Lead Local Flood Authority

RE: DM/26/0184 – Former Site of Unit A, Consort Way, Burgess Hill, West Sussex

This application is for the discharge of planning conditions No's: 7,8,12,13 and 14 relating to planning application DM/24/2970.

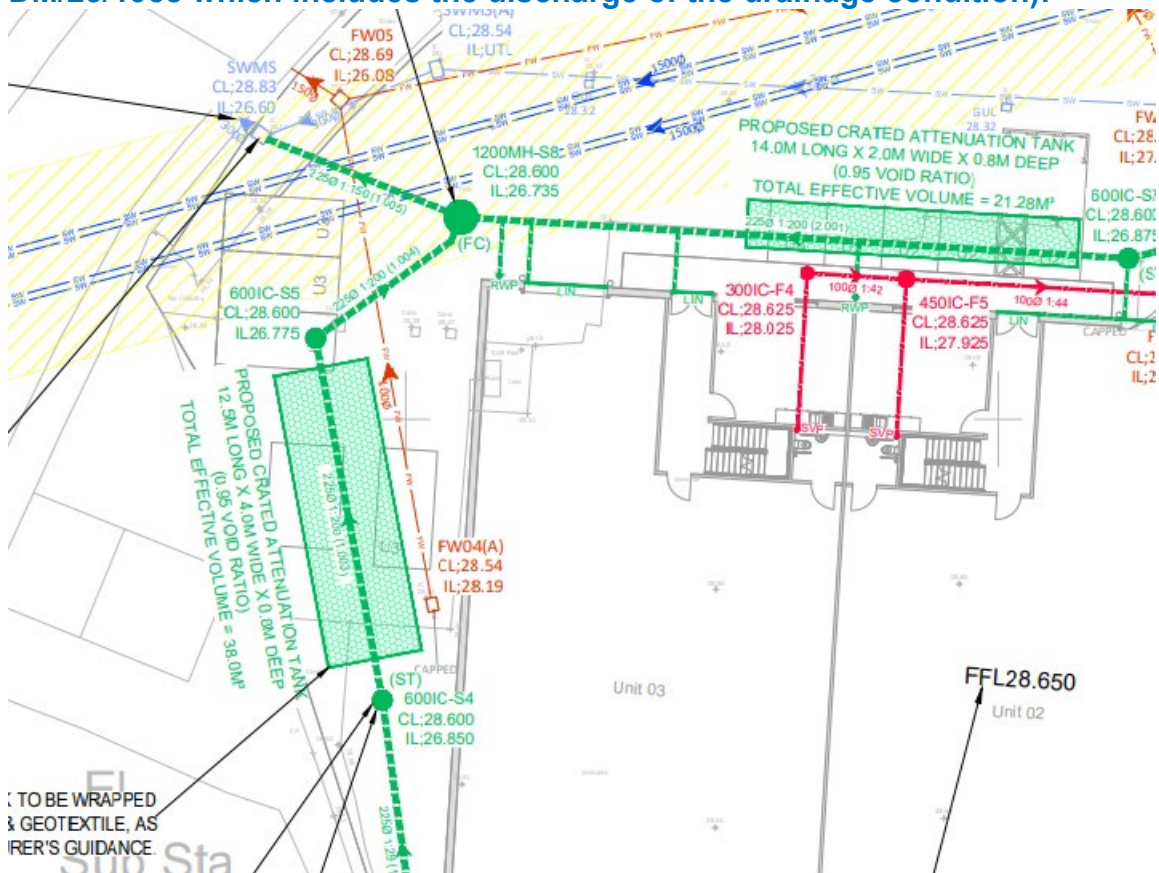
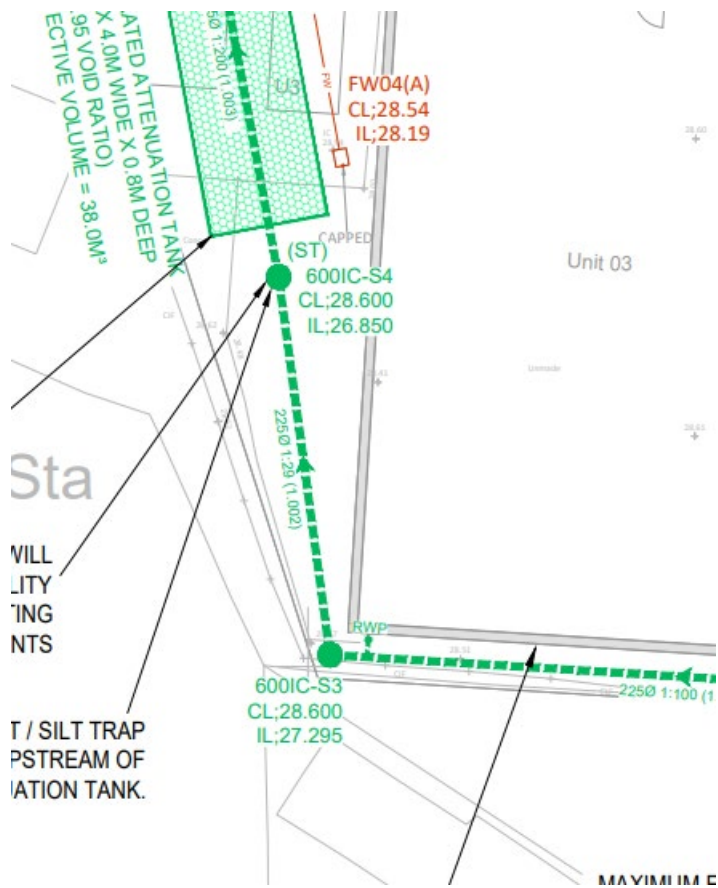
In DM/25/1958, there are 2 tanks with a combined volume of 59. 28m³. The as built drawings from this application show the single tank has a volume of 46m³. **This means the site has been constructed with 13.28m³ less volume of attenuation.** This could increase flood risk within the site or elsewhere.

See screenshots below of some examples (we have not completed a full review comparing the as built with the for construction drawings, as we would expect this to be

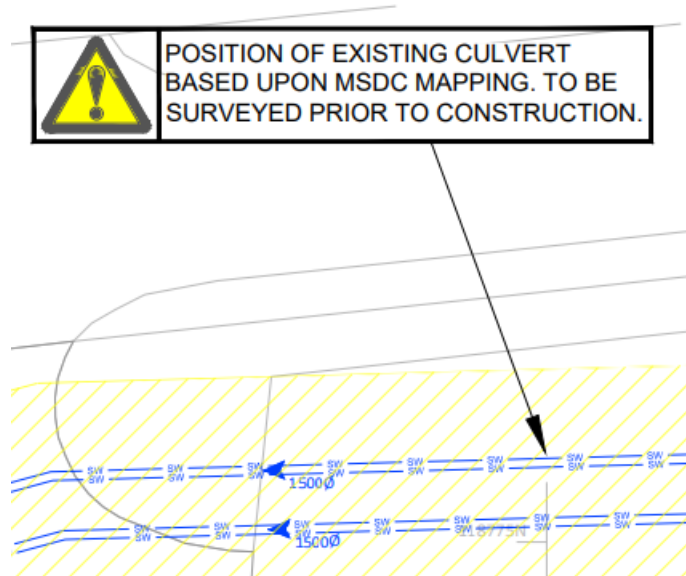
However, the maintenance of the rainwater harvesting appears to be missing.
